NEW FENWAL BOARD HF-4624 REPLACEMENT

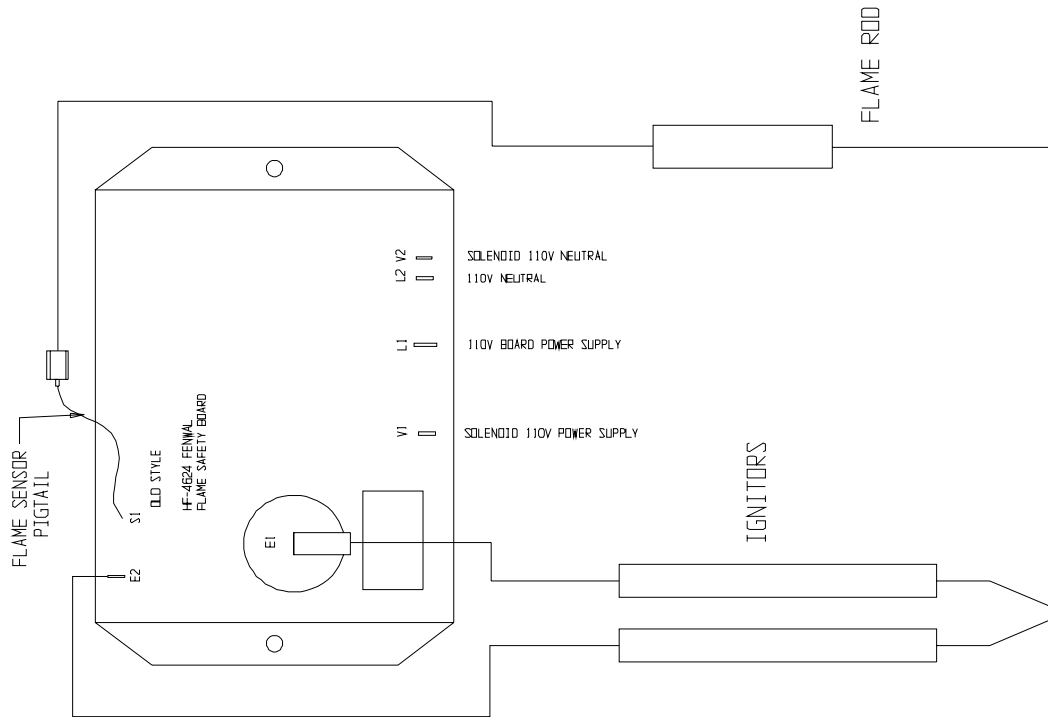
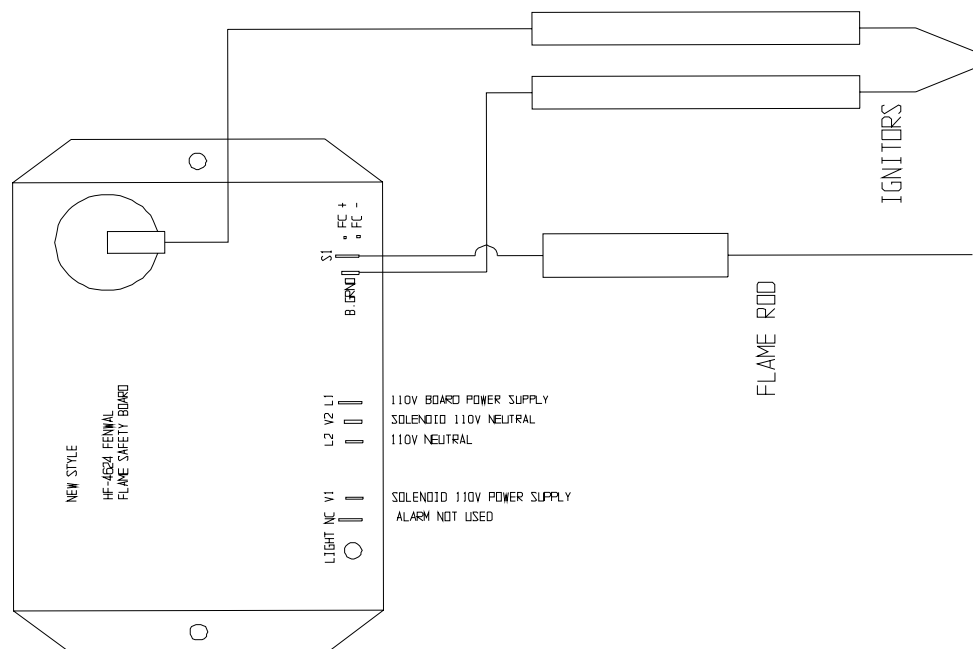
The B. GND terminal is used to complete the flame current signal circuit. This terminal is new for systems that used the older version of the Fenwal board. This terminal must be connected to the one of the ignitors.

DO NOT CONNECT THE B.GND TERMINAL TO BURNER CHASSIS. THIS WILL RESULT IN PREMATURE BOARD FAILURE.

The new board has been designed such that reversing the polarity of the 120 VAC line does not cause a loss of flame signal. Thus providing a more reliable flame signal along with a reduction of nuisance lockouts, due to its design and the use of the B. GND terminal.

Note: Terminal E2 has been replaced by terminal B.GND. on the New style board.
